OS-PCN-2020-007-A New Separation Technology for IR Pulsed Laser SPL PL90

OS-PCN-2020-007-A

New Separation Technology for IR Pulsed Laser

SPL PL90

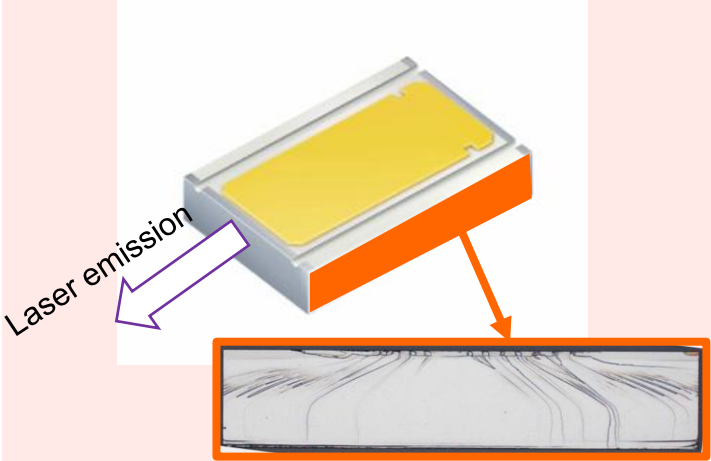
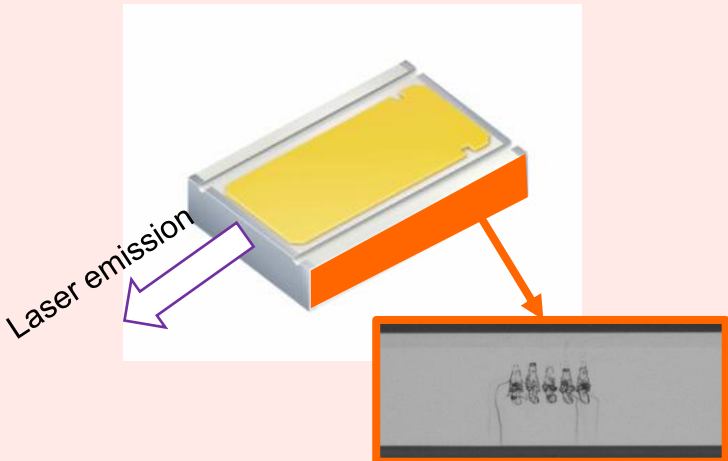
Reason for change: 1. Improved automatization of singulation processes
2. Additional design changes on p-side

2. Description of change

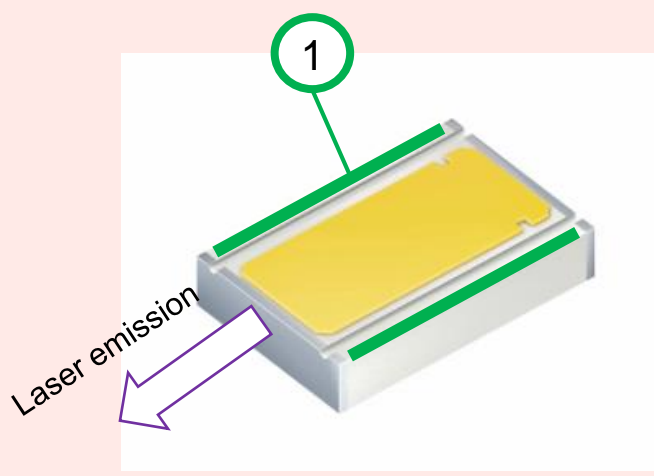
Item	Current status	New status
1	<p>Visible at both laser bar non facet side</p> <p>Both technologies mixed in production.</p>	
1	 <p>Schematic drawing (front side)</p>
